A316/Langhorn Drive Junction, Twickenham, Middlesex

Proposed Development Access

Stage 1 Road Safety Audit

Ref: SG/MF/15-1109

DRAWING NUMBER
30713/AC/038

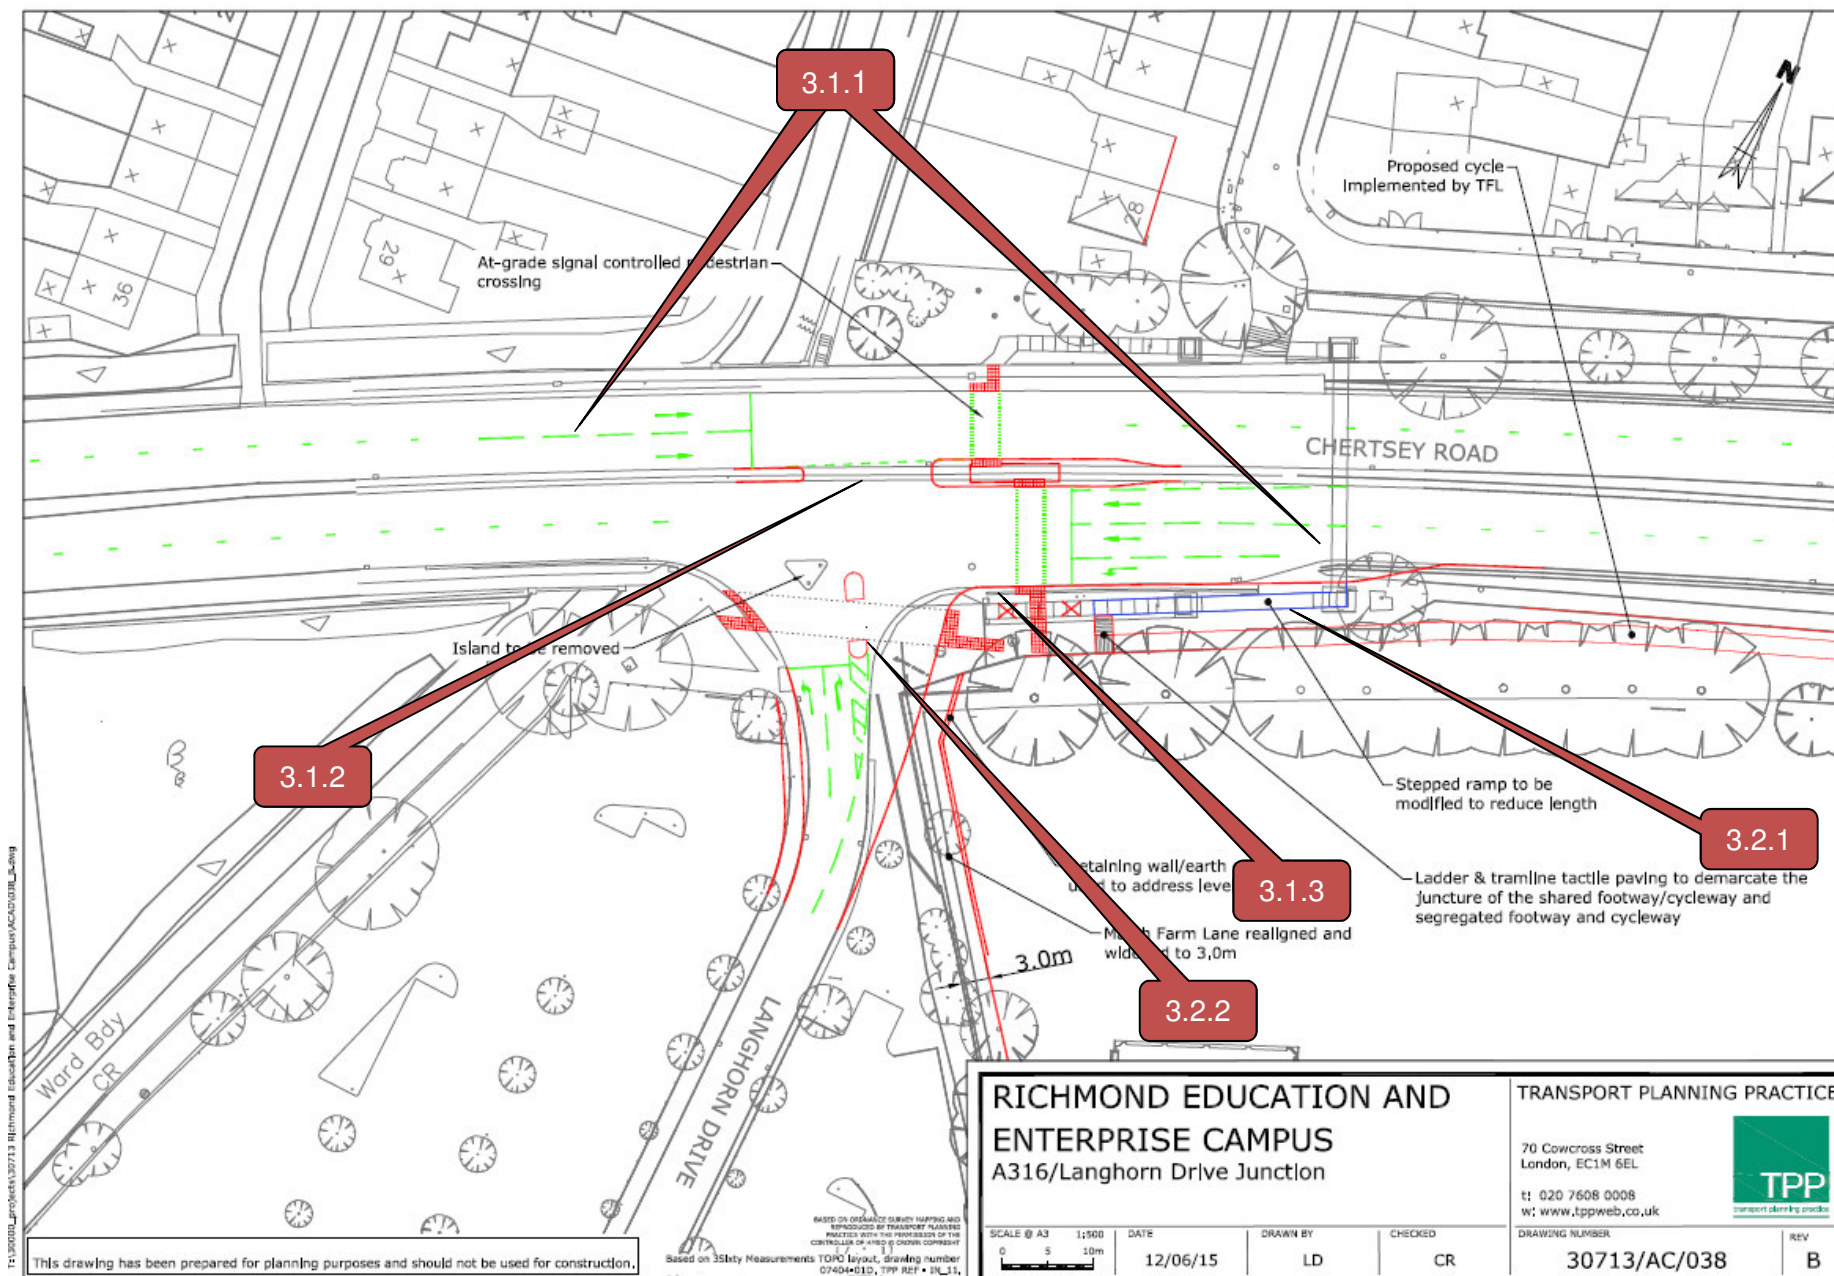
The A316 Chertsey Road is subject to a 40mph speed limit in the vicinity of the proposed traffic signal controlled junction. During the site inspection the Audit Team noted that vehicle speeds broadly comply with the posted speed limit, but during off peak periods vehicle speeds may be higher. The introduction of the traffic signal controlled junction may increase the risk of loss of control type collisions arising from high speed vehicles suddenly braking when the lights change from green to red.

Review the Polished Stone Value (PSV) of the carriageway surface on the A316 Chertsey Road approaches to the traffic signal controlled junction. If necessary, a colour contrasting / high friction surface should be applied to improve skid resistance of the road surface and highlight the presence of the traffic signal controlled junction. In addition, vehicle speed detection loops should be used to trigger an extended amber signal to vehicles exceeding the speed limit on their approach to the signals.

No details of carriageway markings and signs have been provided. The absence of signs and markings may encourage A316 Chertsey Road eastbound traffic to perform an illegal right turn into Langhorn Drive or a U-turn. This could increase the risk of collisions with traffic travelling west along the A316 or traffic turning right out of Langhorn Drive.

Advance road signs and carriageway markings should be provided to inform A316 Chertsey Road eastbound traffic of the permitted movements at the junction.

It is unclear from the drawings provided if forward visibility to the nearside traffic signal head on the A316 Chertsey Road westbound approach will be visible to traffic

approaching the junction. The existing structure associated with the overhead pedestrian bridge may restrict forward visibility to the nearside signal head. Poor visibility to the traffic signal heads could increase the risk of shunt type collisions as left turning vehicles brake.

Ensure that the nearside traffic signal head on the A316 Chertsey Road westbound approach will be visible to traffic approaching the junction.

It is understood that the pedestrian overbridge stepped ramp on the southern side of the A316 is to be modified and reduce in length to facilitate the new junction arrangement. No further details relating to the revised gradient/steps associated with the amended layout of the pedestrian ramped section of the overbridge have been provided. Inadequate provision for non-motorised users of the overbridge may result in a hazard for pedestrian which could result in a trip or fall type of injury.

Ensure that any modifications associated with the pedestrian overbridge stepped ramp comply with highway standards and do not cause a trip/fall hazard for pedestrians.

No traffic signal timings have been provided. The new single-stage crossings will significantly increase the distance pedestrians have to cross. Inadequate inter-green periods could lead to pedestrians becoming stranded, increasing the risk of vehicle/pedestrian collisions.

Provide adequate inter-green periods to ensure that pedestrians are able to clear the crossing without becoming stranded.

Design Organisation Response	Accepted / Part Accepted / Rejected
<p>The PSV assessment can be dealt with at the detailed design stage. However, contrasting colour anti-skid surface treatments are the most likely option to be used to prevent loss of control as they provide an additional warning to drivers that they are approaching a junction / crossing.</p> <p>Additionally, if deemed required by the Stage 2 RSA, speed detection loops could be installed to trigger an extended amber for vehicles detected in excess of the speed limit on the approaches to the junction.</p>	
Client Organisation Comments	
<p>Fusion Project Management Limited accept the above proposals put forward by the Designer on behalf of the client Richmond College.</p>

Design Organisation Response	Accepted / Part Accepted / Rejected
<p>Road markings have been shown on drawing 30713/AC/038 Rev C including lane direction arrows. However, in order to provide further detail, stop lines will be provided in accordance with Diagram 1001, lane markings will be provided in accordance with Diagram 1004 and 1005, the central reservation marking will be provided in accordance with Diagram 1009 and pedestrian crossing markings will be provided in accordance with Diagram 1055.1.</p> <p>Additionally, lane direction arrows on the eastbound carriageway of the A316 Chertsey Road will be in accordance with Diagram 1036.2. Similarly, lane direction arrows on the two ahead lanes on the westbound carriageway of the A316 Chertsey Road will be in accordance with Diagram 1036.2, with the left turn lane being in accordance with Diagram 1036.1.</p> <p>The left turn lane on Langhorn Drive will be in accordance with Diagram 1036.1 and the right turn lane will be in accordance with Diagram 1037.1.</p> <p>Advance road signing and road signing at the junction including Diagram 606: 'Vehicular traffic must proceed in the direction indicated by the arrow', Diagram 612: 'No right turn' and Diagram 614: 'No U-turns' will be used to prevent vehicles turning right into Langhorn Drive from the eastbound carriageway of the A316 and U-turning on the A316 for both for both carriageways.</p> <p>Additionally, the signal heads on the eastbound carriageway of the A316 could be fitted with green arrows rather than standard green lamps to enforce the straight ahead nature of the arm. Diagram 606 and Diagram 612 could also be added to the signal heads.</p>

Design Organisation Response	Accepted / Part Accepted / Rejected
As per DMRB, Vol. 6, Section 2, Part 3, TD50/04, paragraph 2.7: <i>Each traffic lane shall have clear vision of at least one primary signal associated with its particular movement, from a distance equivalent to the DMSSD.</i> The primary signal head on the central reservation of the A316 is visible from the desirable minimum stopping site distance of 120m. The primary signal head on the nearside edge of the carriageway is visible 75m back from the nearside kerb-line and a 120m from the centreline of the carriageway. Additionally, a secondary signal head mounted on the island on Langhorn Drive would be visible 121m from the nearside kerb, therefore meeting the Desirable Minimum Stopping Sight Distance.	
Client Organisation Comments	
Fusion Project Management Limited accept the above proposals put forward by the Designer on behalf of the client Richmond College.

Design Organisation Response	Accepted / Part Accepted / Rejected
The new crossing over the A316 will provide a fully DDA compliant crossing. Details of the gradients of the stepped section can be provided at the detailed design stage at the detailed design stage. However, signing at the start of the

pedestrian steps on the northern side of the A316 will advise less ambulant persons to use the new pedestrian crossing and warn of standard steps off the bridge on the southern side of the carriageway rather than a stepped ramp.

Design Organisation Response	Accepted / Part Accepted / Rejected
<p>The signal phasing allows for a pedestrian stage where all traffic at the junction is held on red. Sufficient inter-green times have been allowed for vehicles to clear the central conflict areas of the junction before the pedestrian phase is run.</p> <p>The pedestrian island on the A316 carriageway is sufficiently long enough to provide protection of the eastbound carriageway crossing from vehicles turning out of Langhorn Drive and enable the implementation of a stop line if this is deemed required at the detailed design stage.</p>	
Client Organisation Comments	
<p>Fusion Project Management Limited accept the above proposals put forward by the Designer on behalf of the client Richmond College.</p>
